ENGINEER'S SUPPLEMENTAL INSTRUCTIONS NO. EIGHT (008)
(Via Posting to FTP Site and Electronic Mail)

RE: Harold D. Thompson Regional Water Reclamation Facility (HDTRWRF)-Phase 1
ENGINEER'S SUPPLEMENTAL INSTRUCTIONS NO. EIGHT (008) (ESI-008)

1 SECONDARY CLARIFIER DRILLED PIER PLAN
 SC-1 SCALE: 1" = 5'

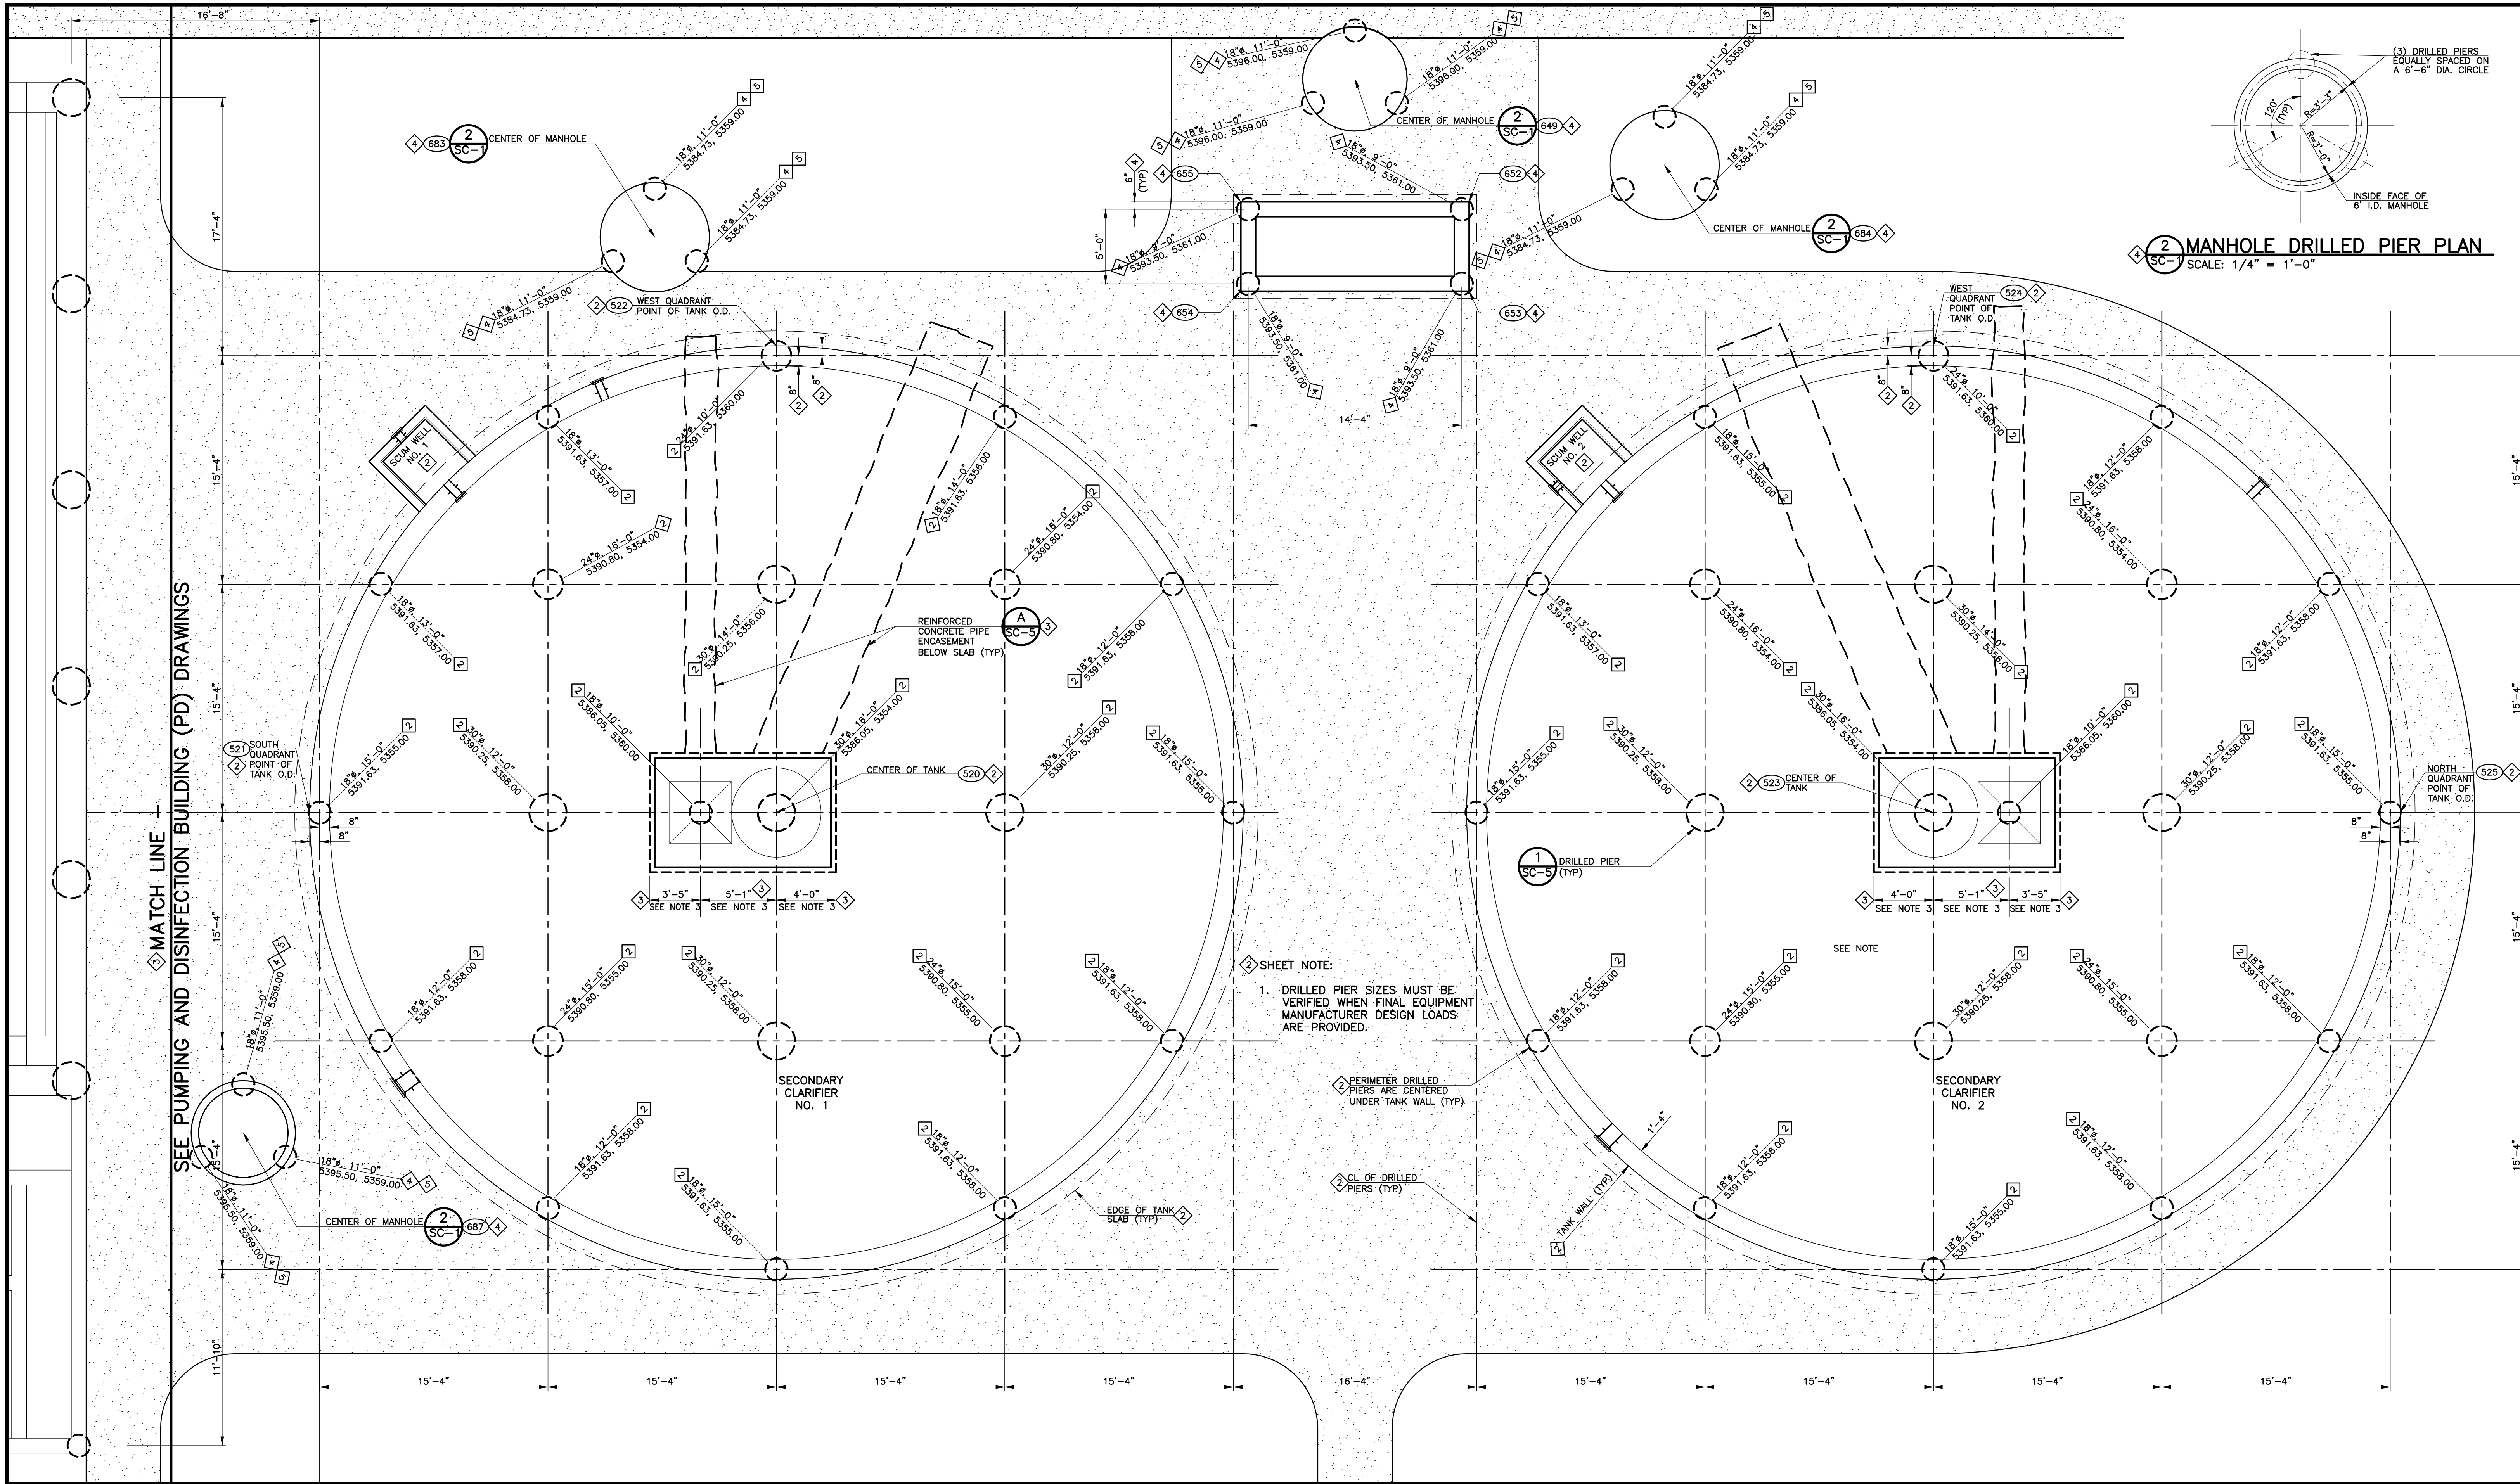
This ESI-008 corrects typographical errors on the Secondary Clarifier Drilled Pier Plan, Drawing SC-1. The estimated bottom of pier elevation has been corrected to be 5359.00, rather than 5369.00, for the drilled piers of four (4) manholes around the Secondary Clarifiers. The drilled piers, and their associated manholes, that have been corrected are as follows:

- 3 drilled piers at the clarifier effluent collection manhole, Manhole MH-06
- 3 drilled piers at the clarifier no. 1 valve manhole, Manhole MH-10
- 3 drilled piers at the clarifier no. 2 valve manhole, Manhole MH-11
- 3 drilled piers at the manhole west of the clarifier influent splitter structure, Manhole MH-05

For convenience, a new issue of Drawing SC-1 including the corrected elevations has been attached to this ESI-008 and uploaded to the project FTP site.
